9675 S.E. 36th ST. MERCER ISLAND, WA 98040  
**89TH AVE SE RESIDENCE**  
 4250 89TH AVE SE MERCER ISLAND, WA 98040

**REVISIONS**

REVISED  
 6.17.2021  
 8.2.2021

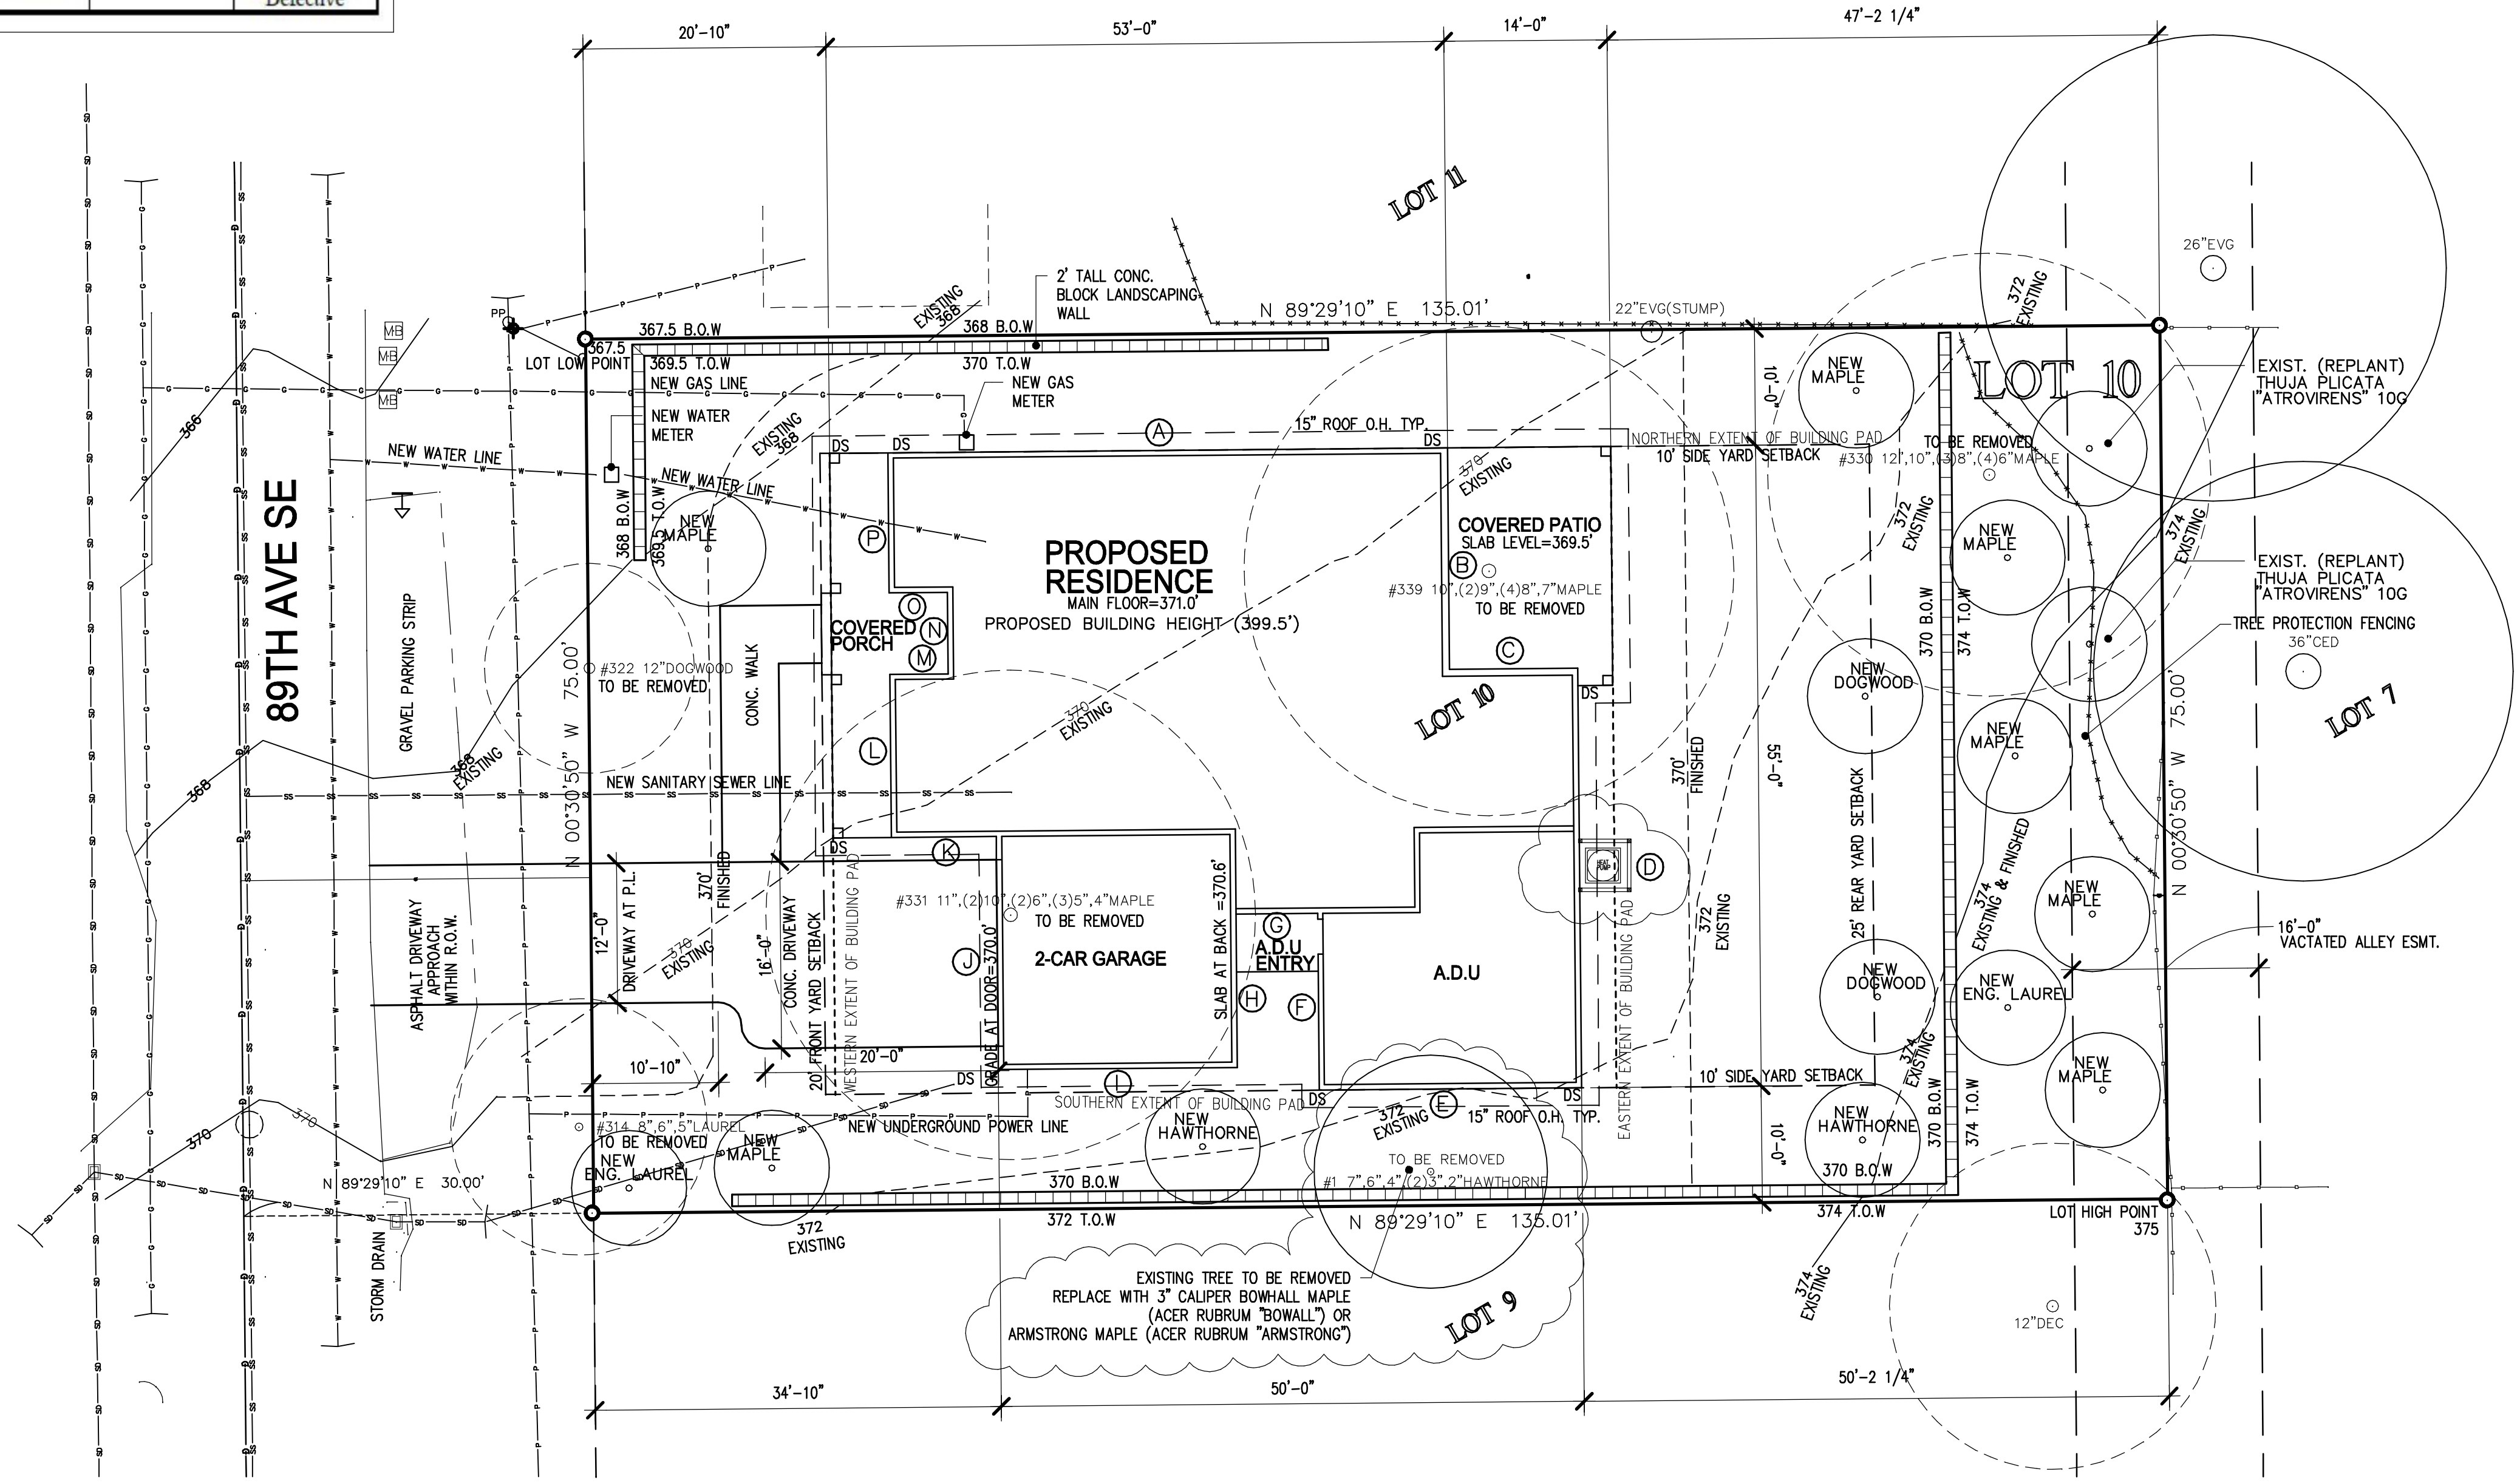
1. ADDRESS UPDATED ON COVER PAGE.
2. HEAT PUMP COMPRESSOR HAS BEEN MOVED TO EAST WALL OF HOME, CENTER OF THE LOT WITH A FENCE SHROUD TO MATCH THE SIDING OF THE HOME. THE HEAT PUMP IS NOW AS FAR AWAY AS POSSIBLE FROM ANY NEIGHBOR AND THE SHROUD WILL DAMPEN THE NOISE FOR THE NEIGHBORING HOMES. THE HEAT PUMP IS NOW SHOWN ON THE SITE PLAN, FLOOR PLAN AND ELEVATIONS

**MERCER ISLAND  
89TH AVE SE RESIDENCE  
MAIN LEVEL FLOOR PLAN**

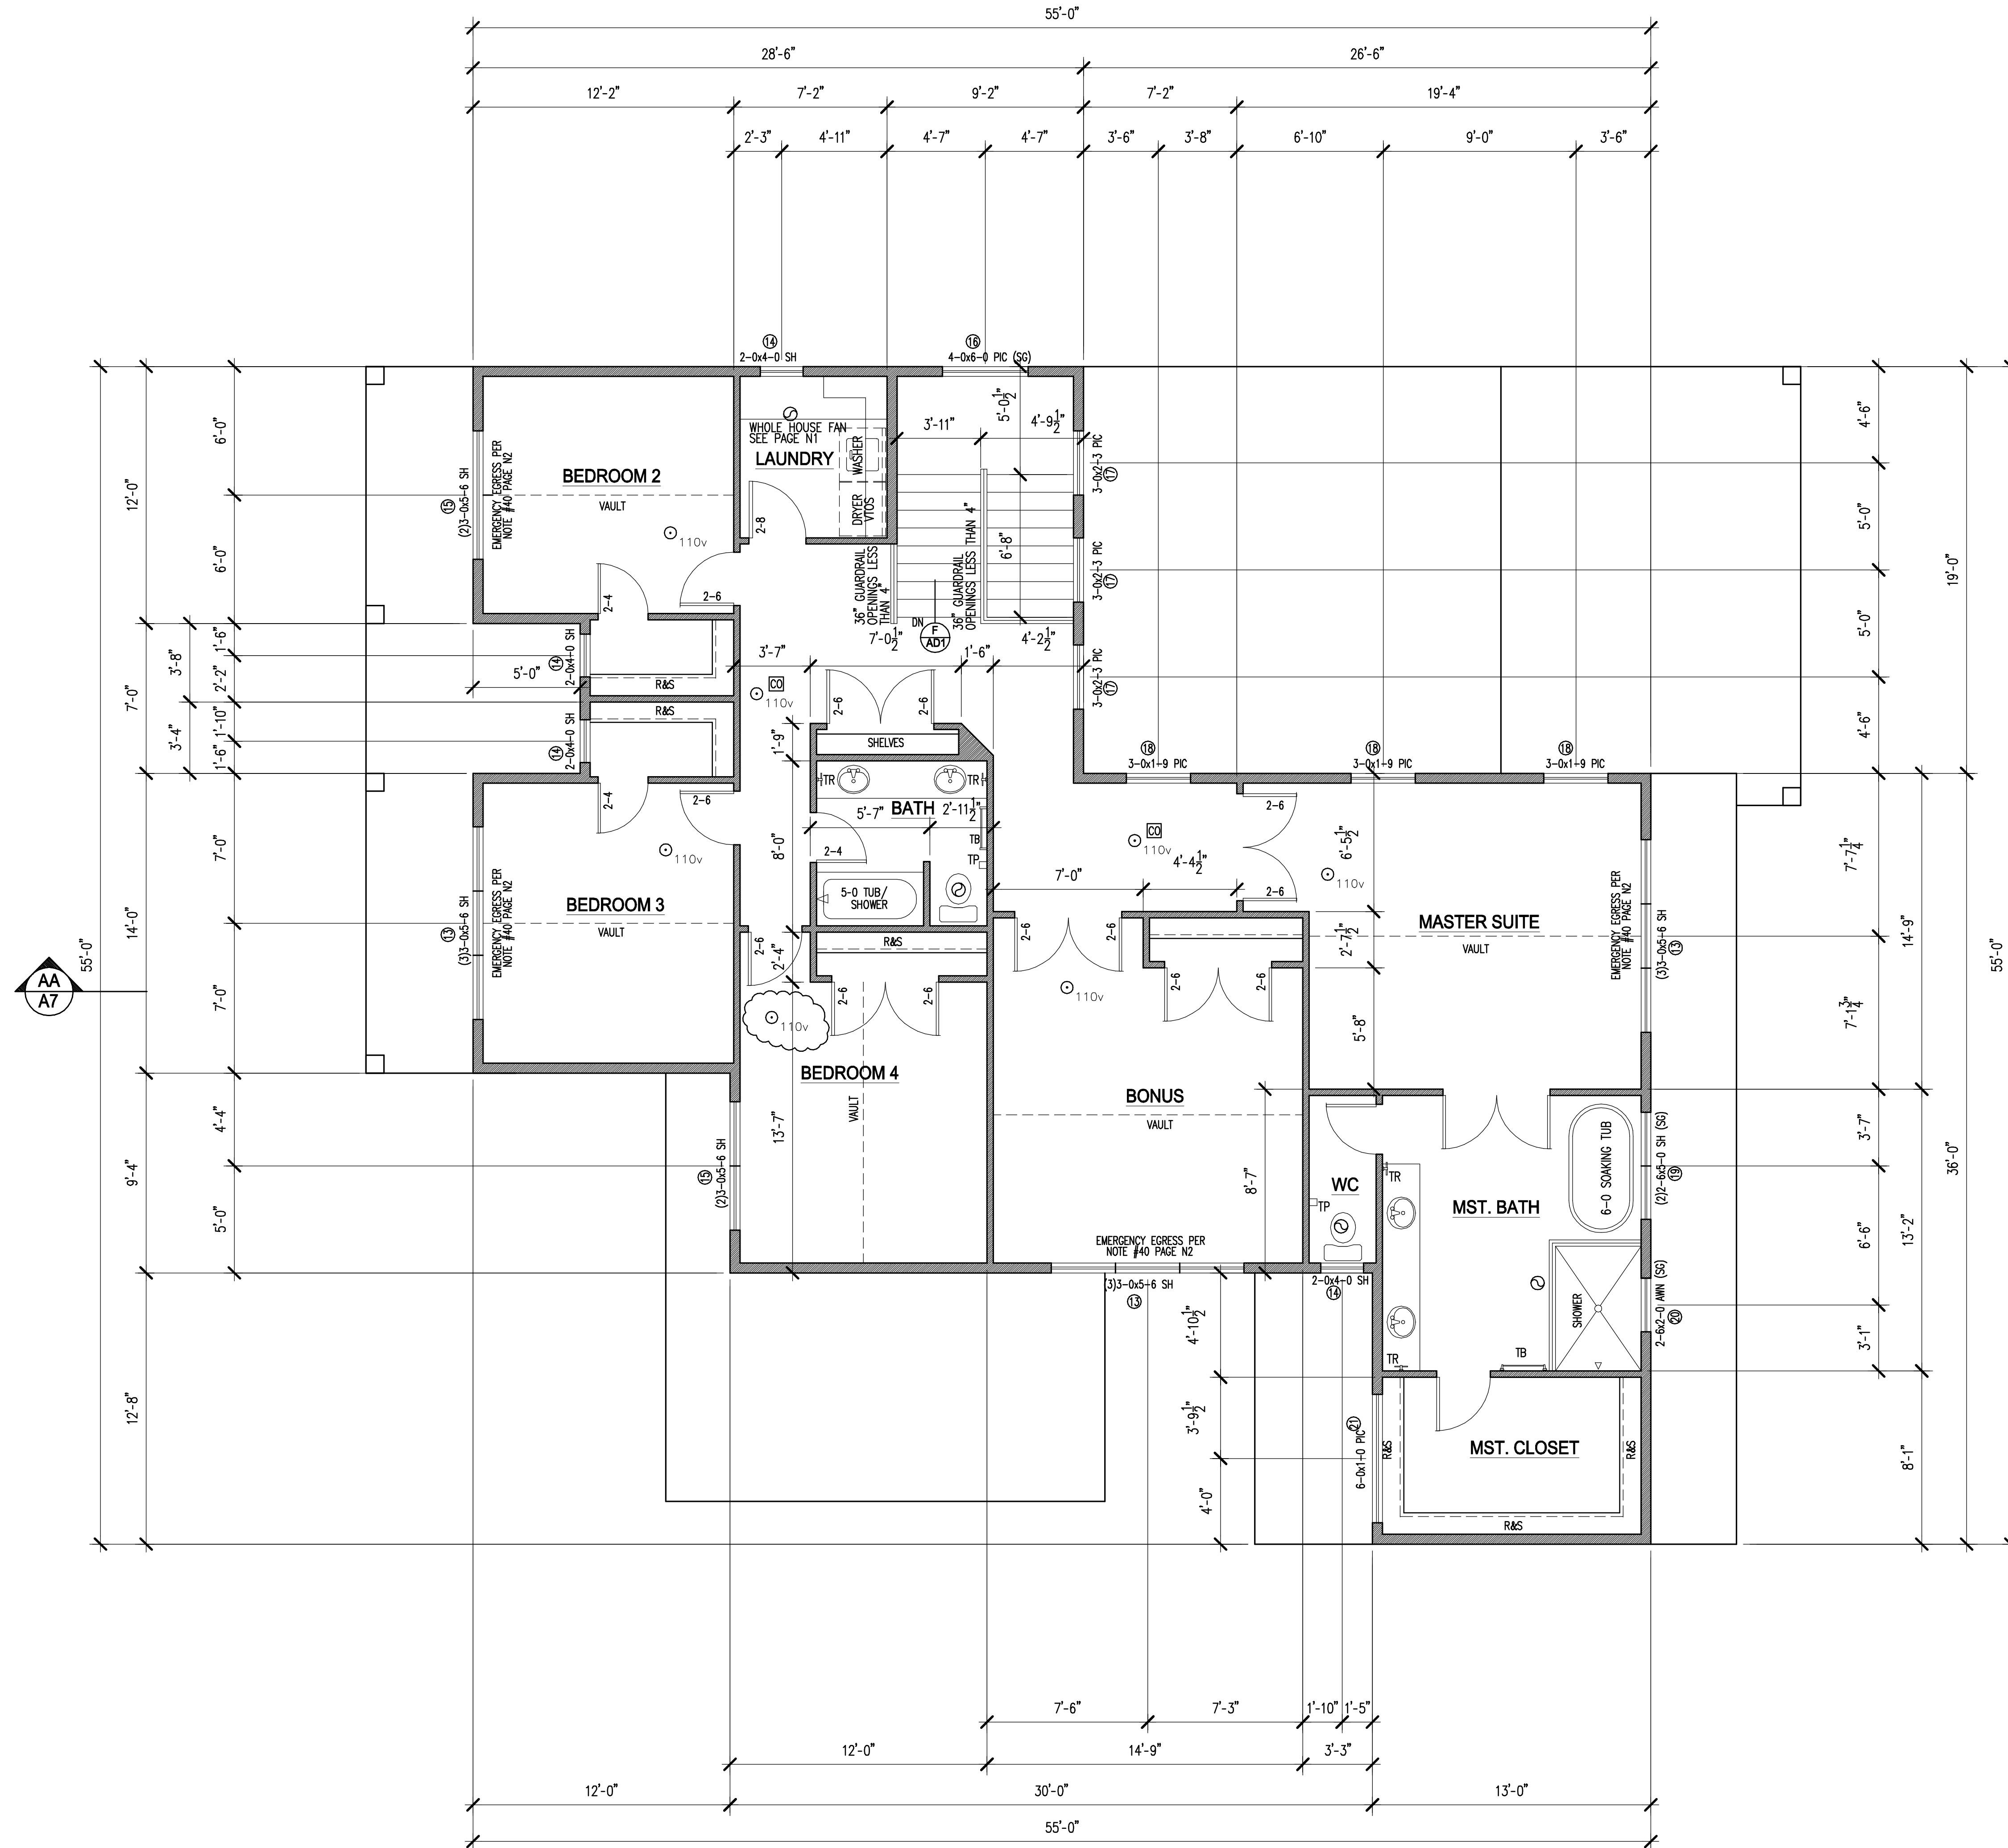
3. NO YARD FENCING IS PART OF THIS PERMIT
4. THE BOOKSHELVES IN THE GREAT ROOM HAVE BEEN REMOVED.
5. SAFETY GLASS HAS BEEN NOTED ON THE NOOK FOLDING DOORS
